Draft Final Engineering Evaluation/Cost Analysis Former Camp Hero Montauk, New York

Subject: Contract DACA87-00-D-0038, Delivery Order 0002
revised Draft Final EE/CA Report Deliverable for
Former Camp Hero, Montauk, New York

FORMER CAMP HERO

Page
SECTION 11 REFERENCES.....	11-1
APPENDIX A – STATEMENT OF WORK (SOW)	
APPENDIX B – ANOMALY DIG SHEETS	
APPENDIX C – SCRAP CERTIFICATION FOR DISPOSAL	
APPENDIX D – INSTITUTIONAL ANALYSIS REPORT	
APPENDIX E - RESPONSE TO COMMENTS

Figure 3.8
Map 4 of 6

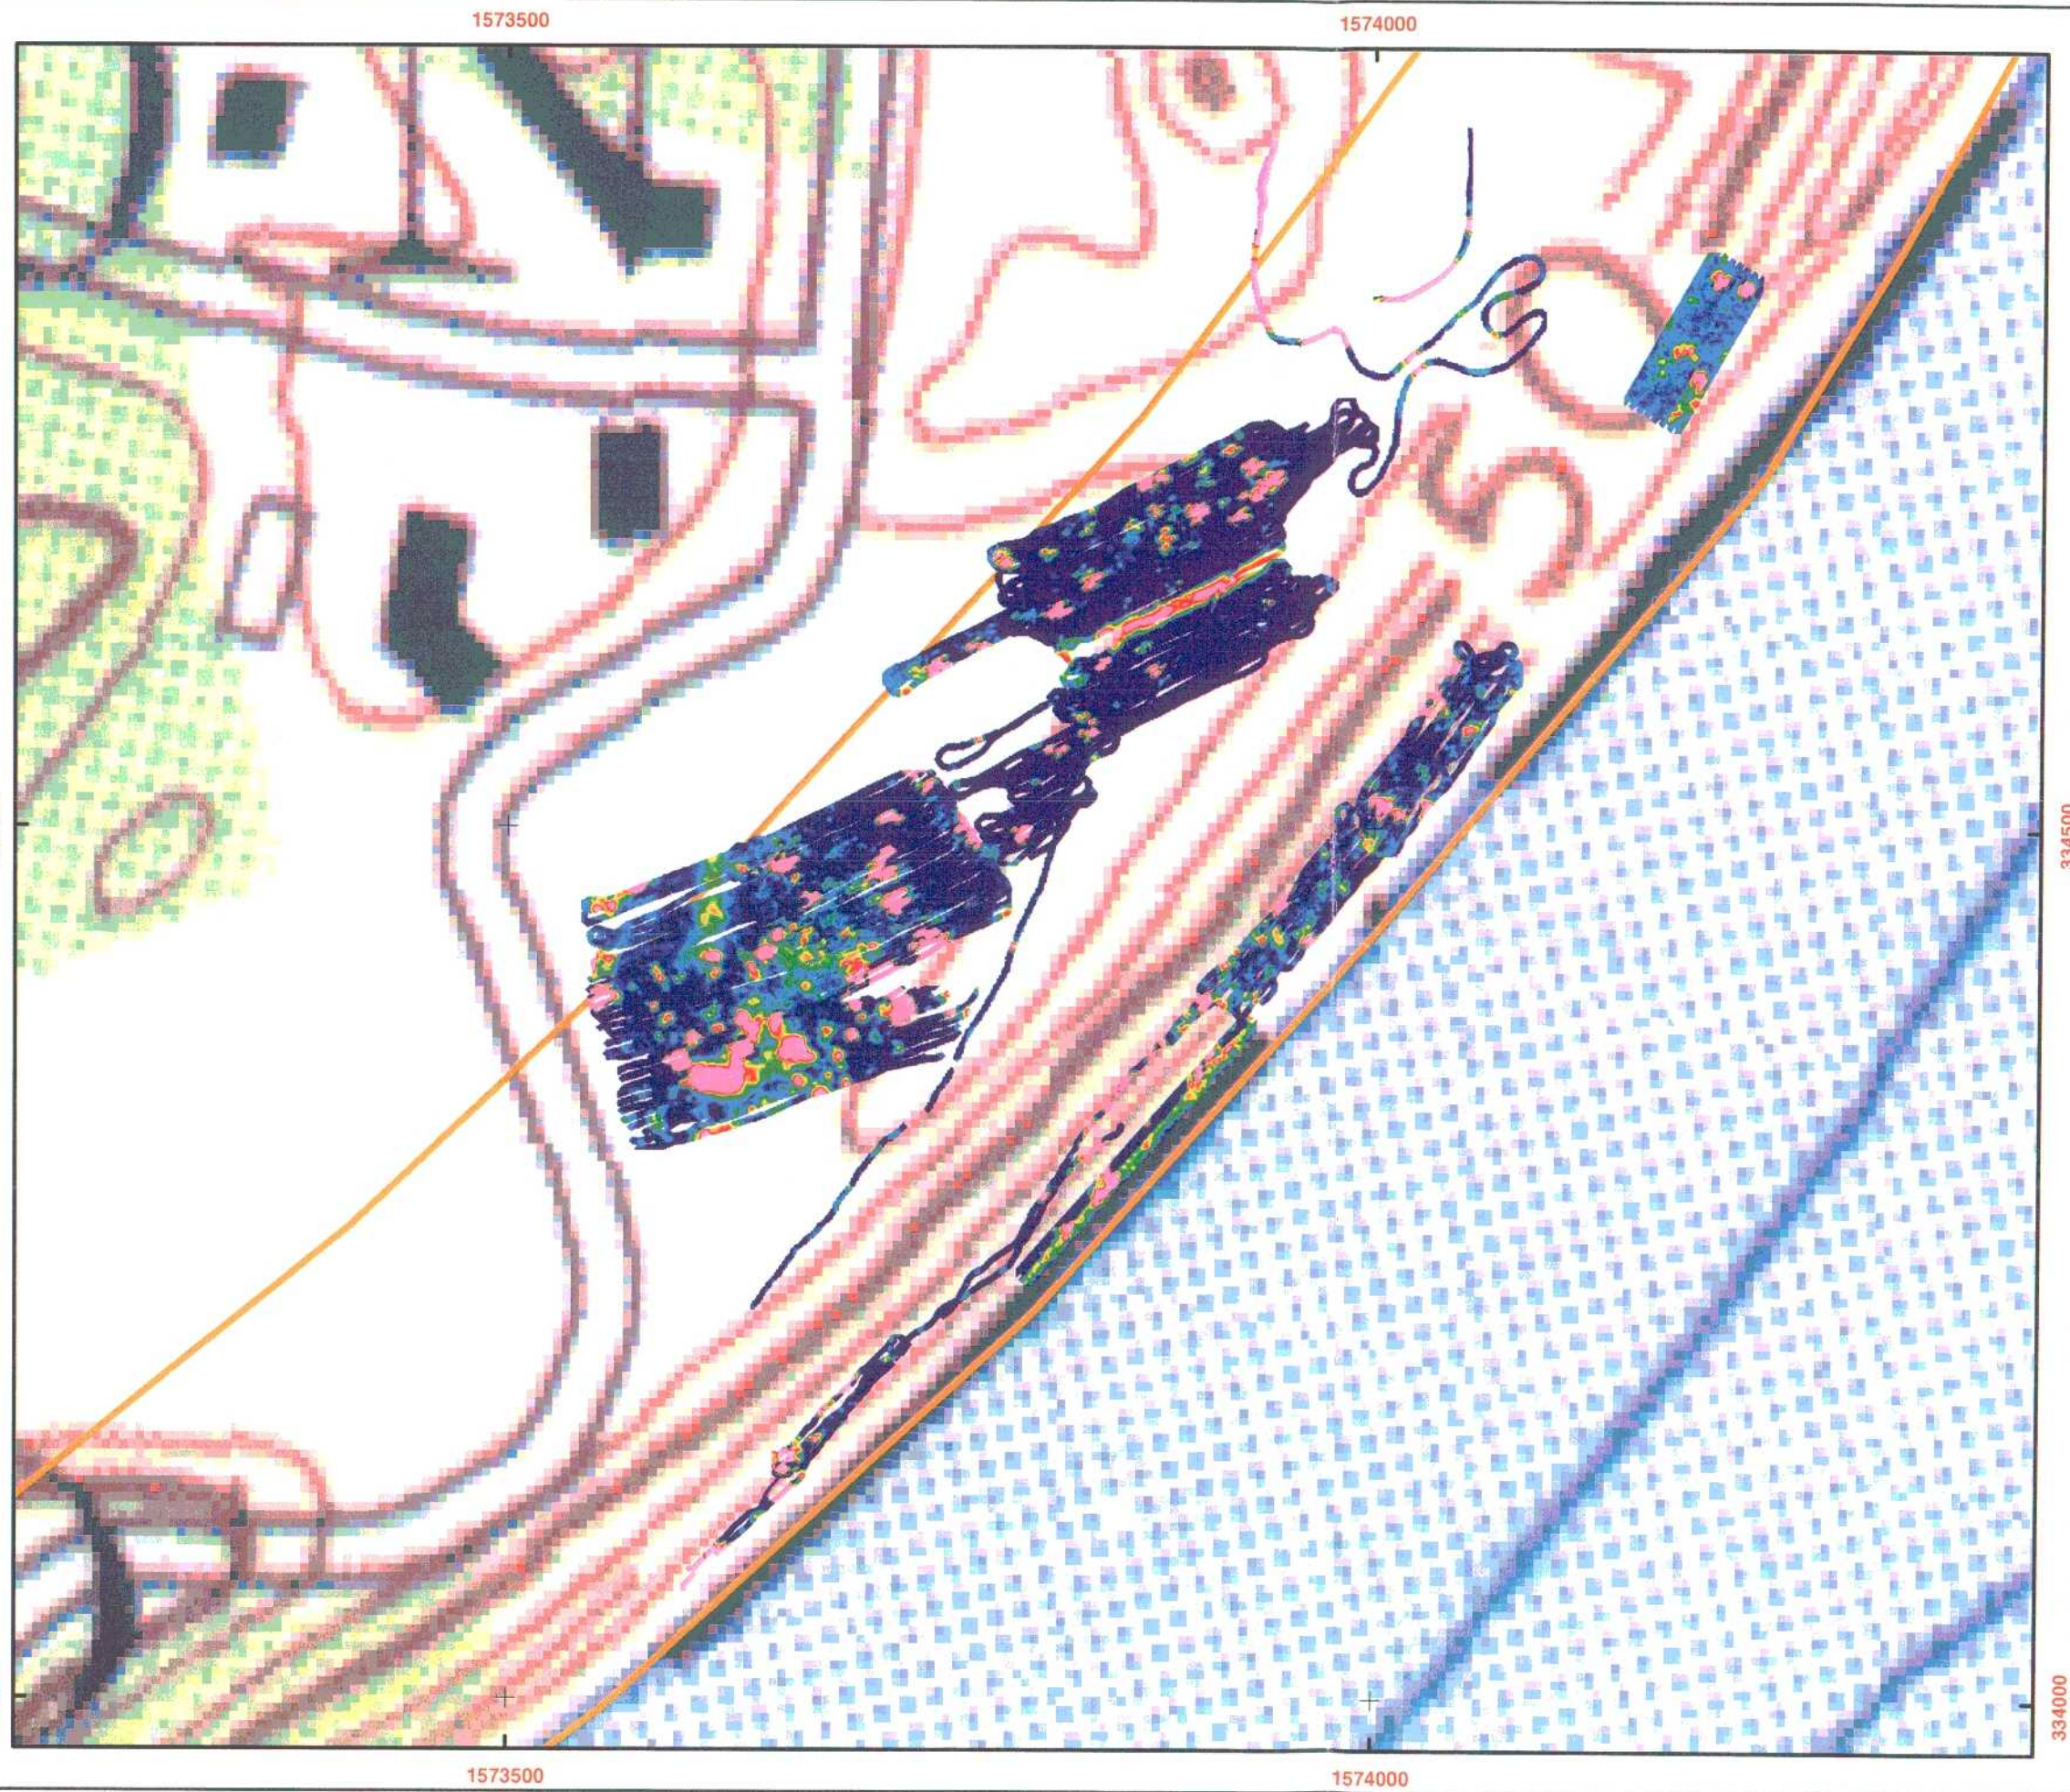
6.	Maps	Recommend adding cultural features as known. For example, in Figure 3.8 Map 4 of 6 there is some cabling which is mapped and is seen coming out of the top of the bluff. Also, the parking area is on this map.	A – Maps were modified with data gathered from the EE/CA fieldwork.

Figure 3.10

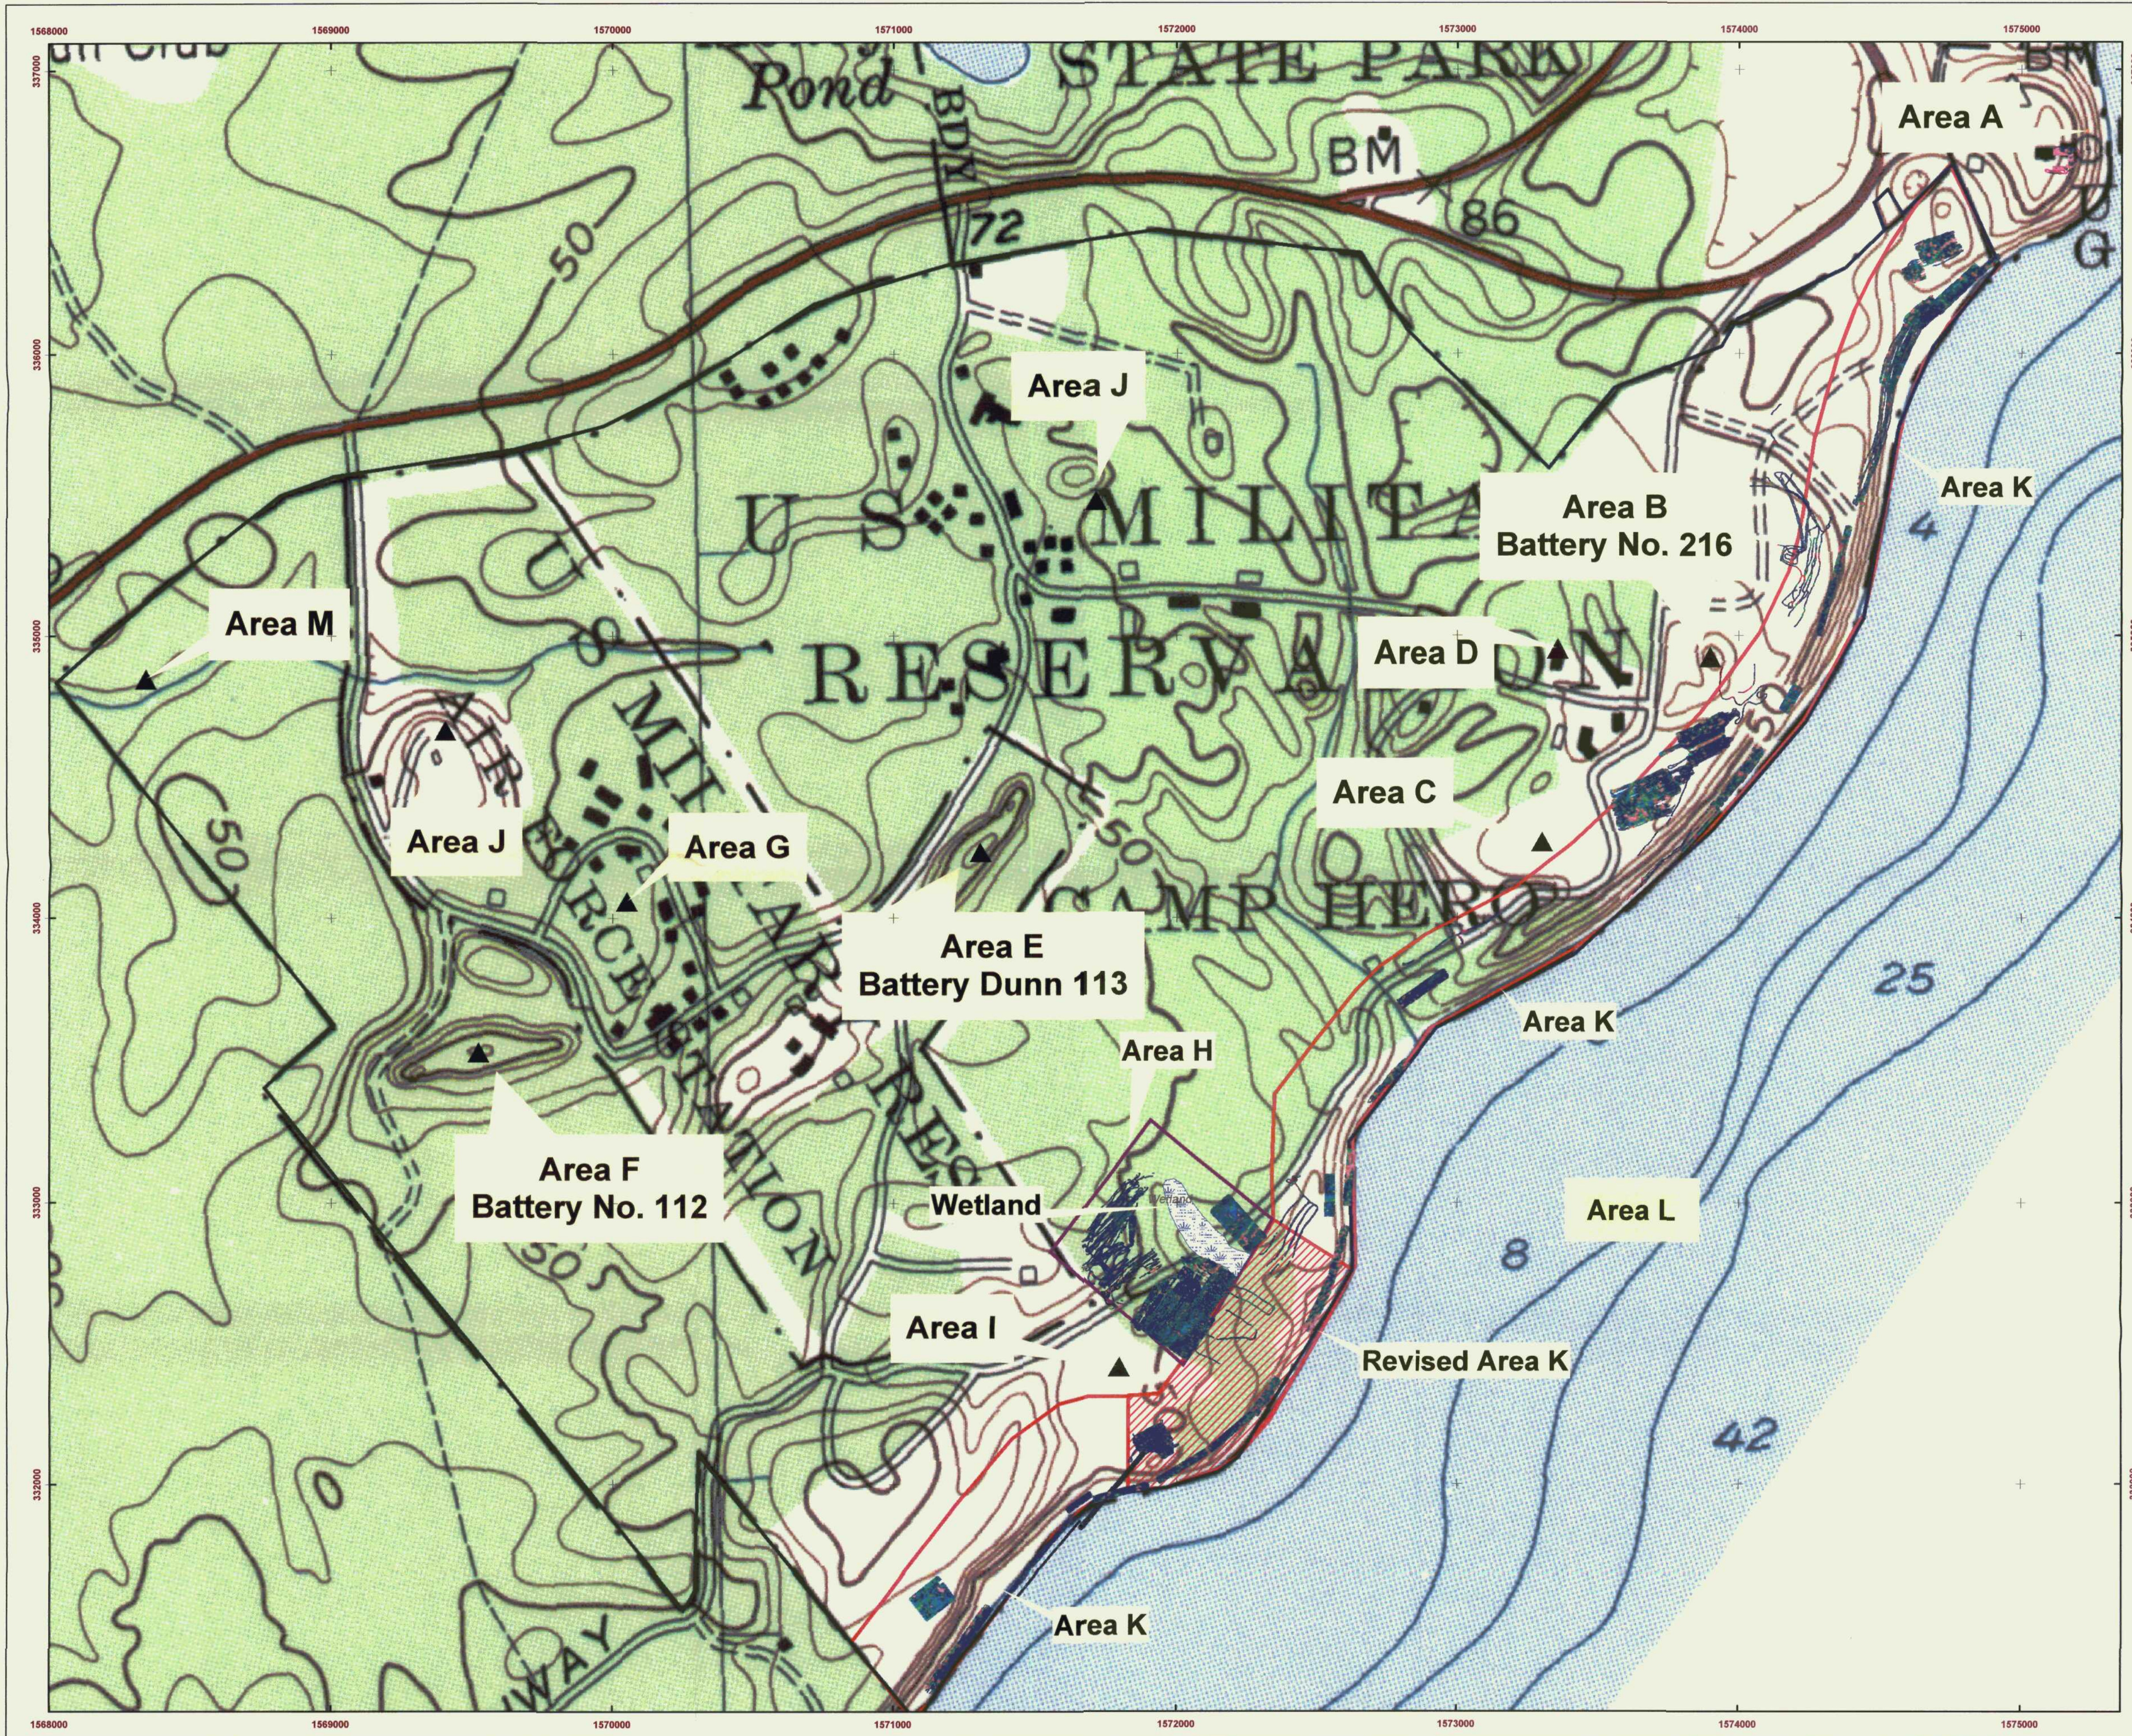
4.	Page 3-31, Figure 3.10	a. The scale is stated correctly within the title block, but I do not know how the bar scale was produced. Why place a bar scale of 1.4" = 420', and then state the scale as 1"=300'. b. The border tick marks are shown with 6 significant digits to the right of the decimal place. Why are we even showing a decimal place within grid ticks?	A – Figure scale and tick mark significant figures revised as requested.
